# Access Compliance Report

## Public Rights-of-Way

### (Curb Ramps)

Intersection ID: 9004	Main Street: BOYD_ST	Cross Street: MARIETTA_ST	Location: S
ADA ID: 2683AD5E162E	Ramp Type: Perp	Initial Pass/Fail: Fail	Overall Compliance: No
Severity Score: 18.75			
Codes/Mitigation Info/Possible Solution		Field Measurements/Component Compliance

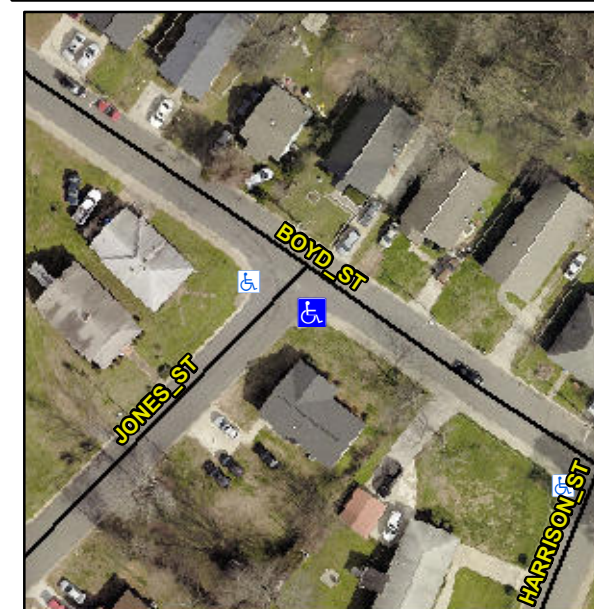
**Not Found, R304.5.1, R304.5.3**

Compliance	Description	Data	Compliance	Description	Data
N/A	Ramp Length (in)	50.0	Yes	Ramp Slope (%)	5.4
No	Ramp Width (in)	35.5	No	Ramp XSlope (%)	3.1
N/A	Flare Type LT	N/A	N/A	Flare Type RT	N/A
N/A	Flare Slope LT (%)	N/A	N/A	Flare Slope RT (%)	N/A
N/A	Flare Traversable LT?	N/A	N/A	Flare Traversable RT?	N/A
N/A	Landing Length (in)	N/A	N/A	DWS Provided?	N/A
N/A	Landing Width (in)	N/A	N/A	DWS Contrast?	N/A
N/A	Landing Slope (%)	N/A	N/A	DWS Length (in)	N/A
N/A	Landing X Slope (%)	N/A	N/A	DWS Full Width?	N/A
N/A	Landing Curb? (Y/N)	N/A	N/A	DWS Offset (in)	N/A
N/A	Shared Landing?	N/A			
N/A	Gutter Ponding?	N/A	N/A	Gutter Slope (%)	N/A
N/A	Gutter Lip Ht (in)	0.5	N/A	Gutter X Slope (%)	N/A
N/A	Painted X Walk1?	No	N/A	Painted X Walk2?	N/A
	X Walk 1 Direction	To NW		X Walk 2 Direction	N/A
N/A	X Walk 1 Width (in)	N/A	N/A	X Walk 2 Width (in)	N/A
	X Walk 1 Slope (%)	1.0		X Walk 2 Slope (%)	N/A
	X Walk 1 X Slope (%)	3.7		X Walk 2 X Slope (%)	N/A

**Remove & Replace Entire Ramp.**
